TECHNICAL SERVICE BULLETIN

Charging system warning message plus battery symbol in instrument cluster with Diagnostic Trouble Code (DTC) P0562-00

24-2072

S-MAX/Galaxy	Year: 2019-2023 Build Date: 12.02.2019 Onwards Build Code: KK Onwards Assembly Plant: Valencia (Spain) Engine: 2.0L EcoBlue (177kW/240PS) (YL) Engine: 2.0L EcoBlue (125kW/170PS) (YN) Engine: 2.0L EcoBlue (132kW/180PS) (YM) Engine: 2.0L EcoBlue (140kW/190PS) (BC)
Mondeo	Year: 2019-2022 Build Date: 12.02.2019 Onwards Build Code: KK Onwards Assembly Plant: Valencia (Spain) Engine: 2.0L EcoBlue (177kW/240PS) (YL) Engine: 2.0L EcoBlue (132kW/180PS) (YM) Engine: 2.0L EcoBlue (140kW/190PS) (BC)

E429149

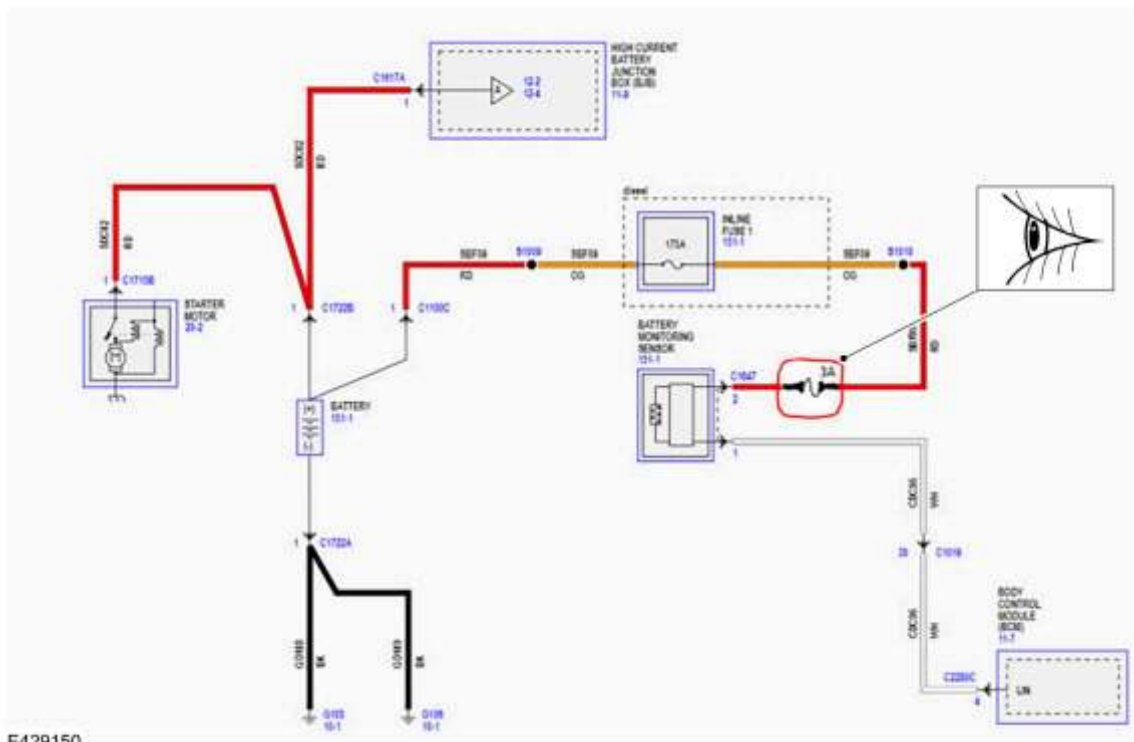
4. Locate the fuse in the wiring harness SBF09 to the Battery Monitor Sensor (BMS) in the near of electrical connector **C1647** Pin 2 (under the silver insulating tape) which is not in the wiring schematic located between the EGR valve and the battery plus pole (refer also to the following **updated** wiring schematic for details).

- Carefully remove the isolation from the wiring harness branch to the BMS electrical connector.
